Item for Zoning and Platting Commission Agenda

COMMISSION MEETING DATE REQUESTED:	March 19, 2019
NAME & NUMBER OF PROJECT:	Forest Bluff Section 7 Preliminary Plan C8J-2019-0011
NAME OF APPLICANT OR ORGANIZATION:	Israel Ramirez, P.E., 512-836-4793 John S. Lloyd
LOCATION:	F.M. 969, Austin, 78725
COUNCIL DISTRICT:	Council District does not apply in Extraterritorial Jurisdiction
ENVIRONMENTAL STAFF:	Pamela Abee-Taulli, Environmental Review Specialist Senior 512.974.1879, pamela.abee-taulli@austintexas.gov
WATERSHED:	Decker Creek Watershed, Suburban classification, Desired Development Zone
ORDINANCE:	Watershed Protection Ordinance (current code)
REQUEST:	Variance requests are as follows: <ol style="list-style-type: none">1. Request to vary from LDC 30-5-341 to allow cut exceeding four feet.2. Request to vary from LDC 30-5-342 to allow fill exceeding four feet.
STAFF RECOMMENDATION:	Staff recommends these variances, having determined the findings of fact to have been met.

Project Name: Forest Bluff Section 7 Preliminary Plan

Variance Request: To vary from LDC 30-5-341 to allow cut exceeding four feet.

Exhibit A
Original Forest Bluff preliminary plan
C8J-00-2251.01

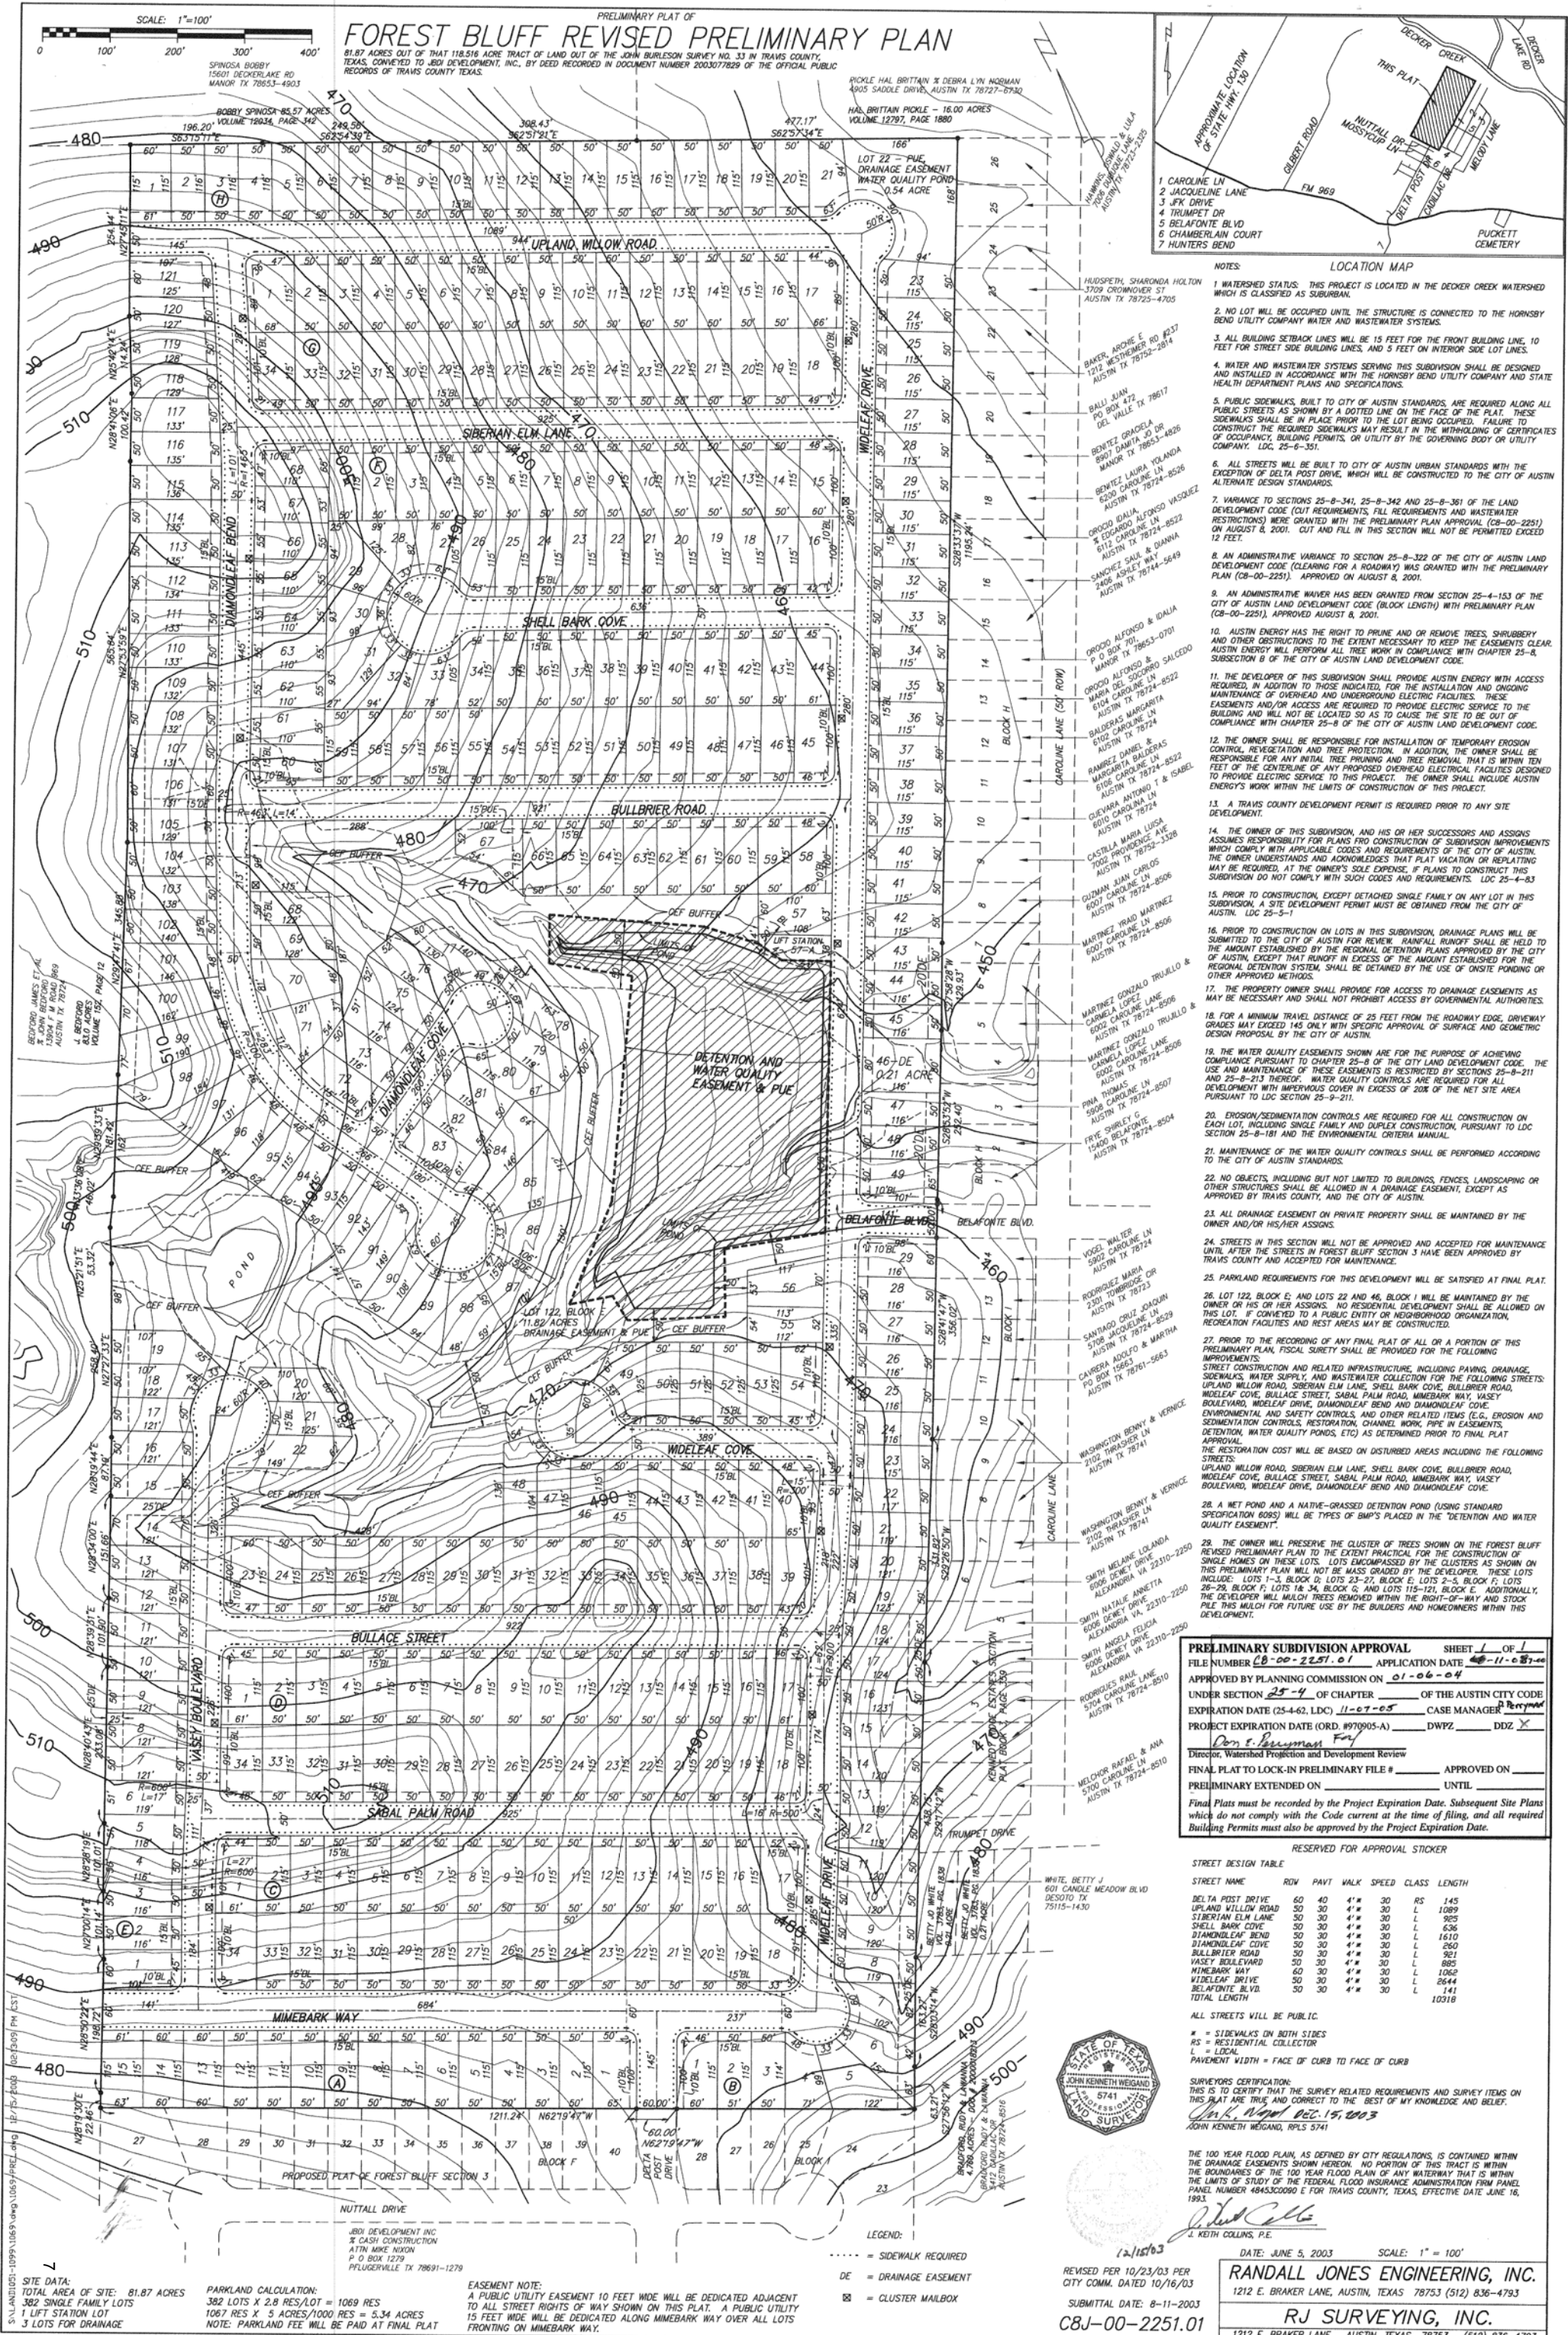
The original Forest Bluff preliminary plan (C8J-00-2251.01, Exhibit A) has expired, causing the need for this new preliminary plan to be submitted. Per the Vested Rights Determination findings (11/30/2016), “the 2000 preliminary plan has expired as of 8/8/2006. This preliminary plan was submitted and approved prior to Title 30, therefore extensions of the preliminary plan are not allowed by code.”

Variances for cut and fill to twelve feet were granted with the original preliminary plan. The current preliminary plan covers the seventh and final section of a seven-phase, 81-acre subdivision for which phases one through six have already been completed. The previously approved variances applicable to phase seven expired when the preliminary plan expired. The applicant is required to submit a new preliminary plan for phase seven. The current preliminary plan needs cut and fill between eight and twelve feet in order to tie- in to existing roadway and waste-water infrastructure constructed with the original plan.

FOREST BLUFF SECTION 7 CUT/FILL WITH SLOPES EXCEEDING 15% EXHIBIT

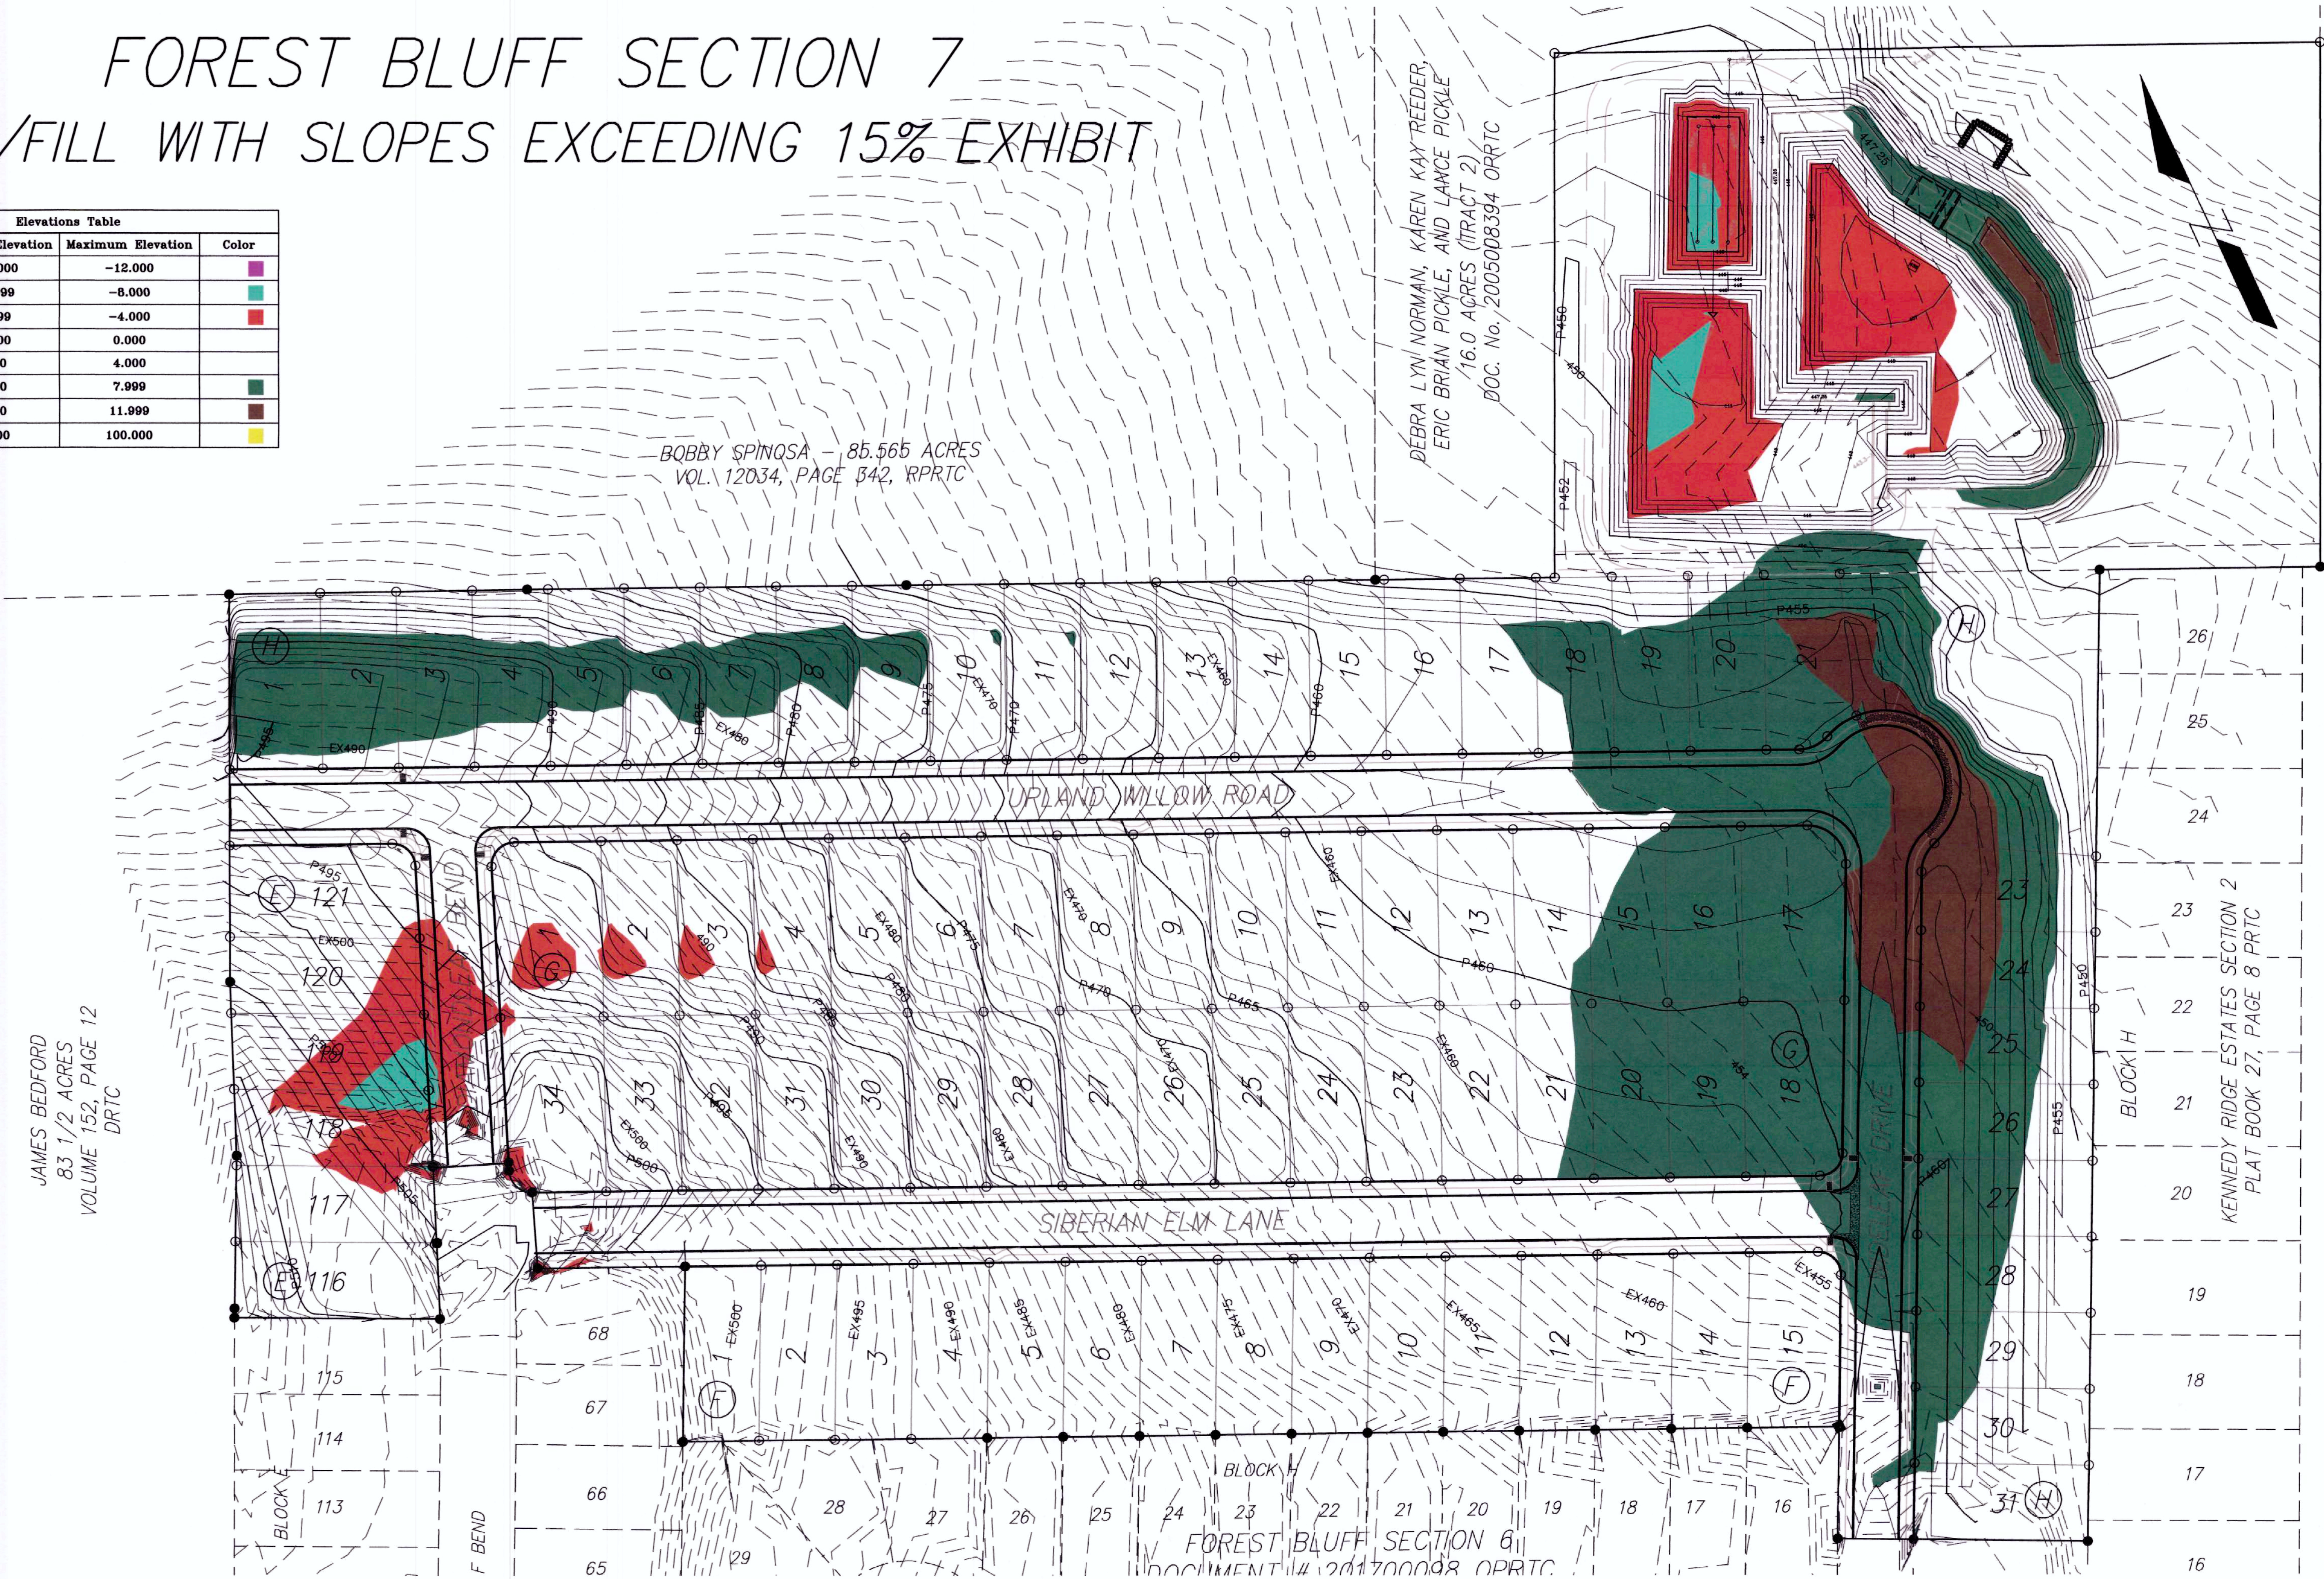
Clearly indicate in what way the proposed project does not comply with current Code (include maps and exhibits)	The project proposes cut and fill greater than 8 feet to allow connections to the existing streets built with Forest Bluff Section 6 and to connect to underground utilities with proper depth of cover. The grading, streets, and utilities approved with Forest Bluff Section 6, which are now existing, have caused Section 7 to not comply with current code, creating the need for this variance.
---	--

The variance is necessary in several locations, shown on the provided exhibit, for the following reasons:

- 1) To tie into the existing roadway at Diamond Leaf Bend and Siberian Elm Lane;
- 2) To tie into the existing roadway and wastewater line at Wideleaf Drive;
- 3) To provide depth of cover for utilities along Wideleaf Drive and Upland Willow Road;
- 4) To provide surface drainage for lots along Upland Willow Road; and
- 5) To provide surface drainage for lots along Siberian Elm Lane.

THEREFORE, the Environmental Commission recommends support of the requests to vary from LDC 30-5-341 to allow cut exceeding four feet and LDC 30-5-342 to allow fill exceeding four feet with the following conditions:

- Cut and fill are not to exceed twelve feet.

**FIGURE 1**

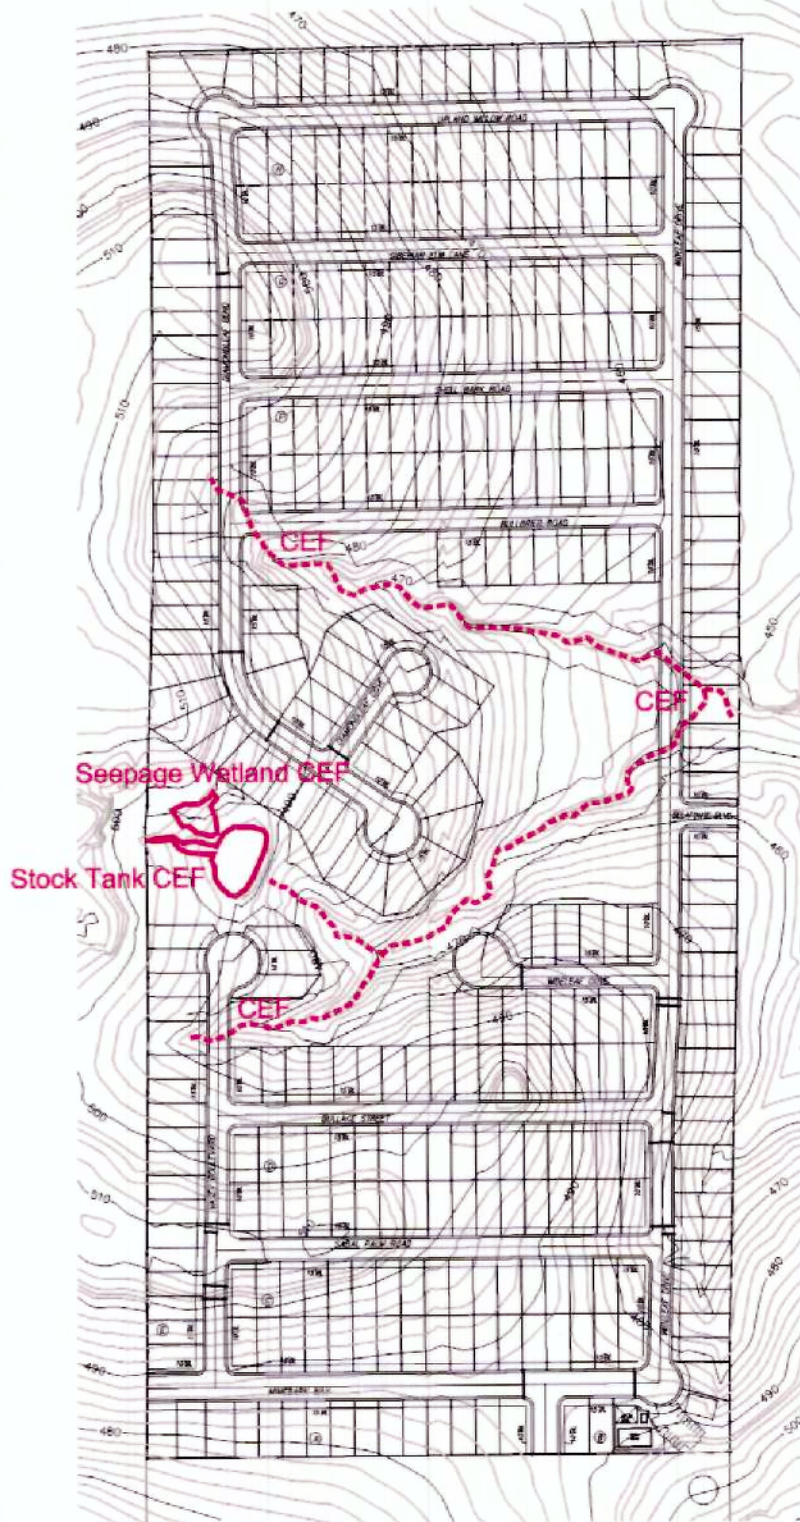
Critical environmental features (CEFs), as defined by the COA, include such features as springs, seeps, canyon rimrocks, bluffs, caves, sinkholes, wetlands, or water wells. Several wetland CEFs are located on the subject site (Figure 1).

The 2 main ephemeral tributaries traversing the subject site have numerous small wetland areas located along their lengths. For the most, part these areas are not contiguous, and are separated by areas of upland vegetation. These wetland areas lie within the stream channel or immediately adjacent to the stream channel. During the field investigation, both tributaries were not flowing.

The stock tank located in the western portion of the subject site is also considered a wetland CEF. This area can be described as a small open water stock tank with a narrow band of hydric vegetation along its margins. The stock tank was created by impounding the ephemeral sub-tributary and has an overflow spillway on the southern side of the dike.

Another wetland area is located immediately northwest of the stock tank. This area can be characterized as a seepage wetland. No identifiable flow was noted during the field review; however, hydric species dominate this zone. Species include several rushes (*Juncus* spp.), sedge (*Carex* sp.), spikerush (*Eleocharis* sp.), and annual sumpweed (*Iva annua*).

On December 22, 2000 you and I investigated the above referenced project site for the presence of wetland Critical Environmental Features (CEFs). Several fringe wetlands and headwater wetland areas were identified along two tributaries in the northern end of the property. These two tributaries converge near the eastern property line. The south fork was fringed along much of its length with Spikerush (*Eleocharis* sp) and both tributaries had marshy seeps at their headwaters which were dominated by Spikerush plant communities as well. Both streams had measurable flow on the date of this investigation and are considered Waters of the United States. Although the streams are unclassified and do not have critical water quality zones, the wetlands do meet the Army Corps' technical criteria as wetlands since a Spikerush dominated plant community is Facultative-wet or Obligate and an abrupt boundary separates these communities from the upland plant communities. Hydrology was present (saturated to the surface or within one foot of the surface) and soils can be assumed within a facultative/obligate dominated plant community. Therefore, these wetland areas are considered CEFs and protected by Austin's Land Development Code, Section 25-8-282.

The standard setback for CEFs is 150 feet; however, I recommend that each of these tributaries receive a CEF buffer of 50 feet from the centerline of the waterway for their entire length instead of 150' setbacks around each small wetland. This modified setback will better protect the riparian woodlands and hydrology to and from the wetlands than the standard setback and be less intrusive to the development of the property. Water quality and drainage easement is proposed at the confluence of these tributaries and lot lines are proposed within the recommended setback. Lot lines should be pulled back 50' from the centerline. Water quality may be considered if wet ponds are proposed as mitigation for losses of CEFs and buffers; however, the wetpond should also receive a 50' native forested buffer. Road crossing may be allowed if trees are replaced, but intersections should be moved away from the recommended buffers and centerline of the streams (see southern fork at western headwaters for this intersection).
